FINAL ENVIRONMENTAL STATEMENT

Confined Disposal Facility and Maintenance Dredging of the

Les Cheneaux Island
Federal Navigation Channels, Michigan

U.S. ARMY ENGINEER DISTRICT DETROIT, MICHIGAN

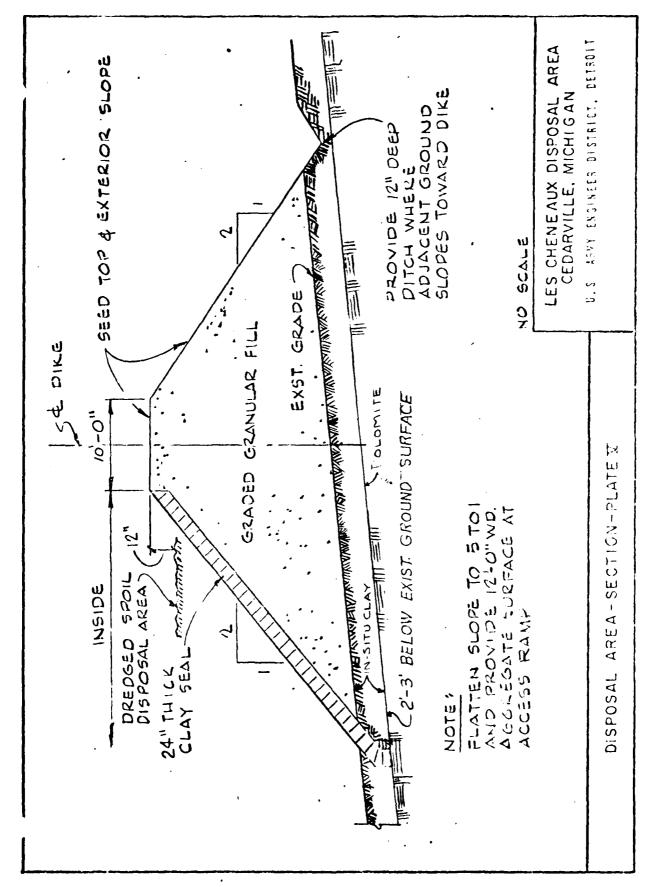
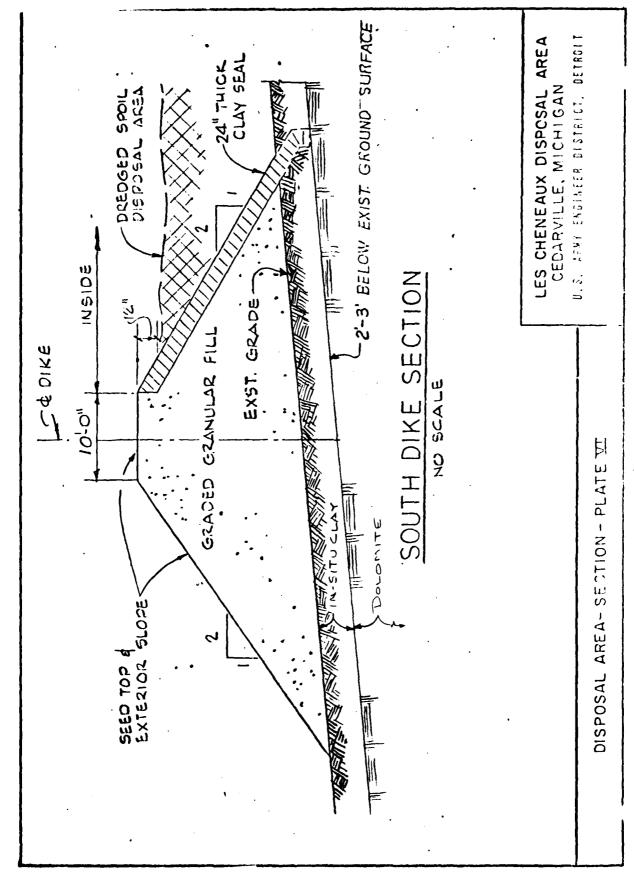
2. <u>Comment</u>: According to paragraph 1.08, the 7 acre upland disposal area "...will be entirely sealed with an approximately 24" thick layer of clay to prevent potential contamination of groundwater supplies..." We agree that at least 2 feet of clay should be used to seal the sides and floor of the disposal area. The plates on pages 60 and 61 should

be corrected to show 24" thick clay seal instead of a 12" thick clay seal. The location of the Clark Township Landfill as shown on Plate 1A (page 55) should also be corrected.

Response: Plates V and VI have been changed to show the planned 24 inches of clay seal.
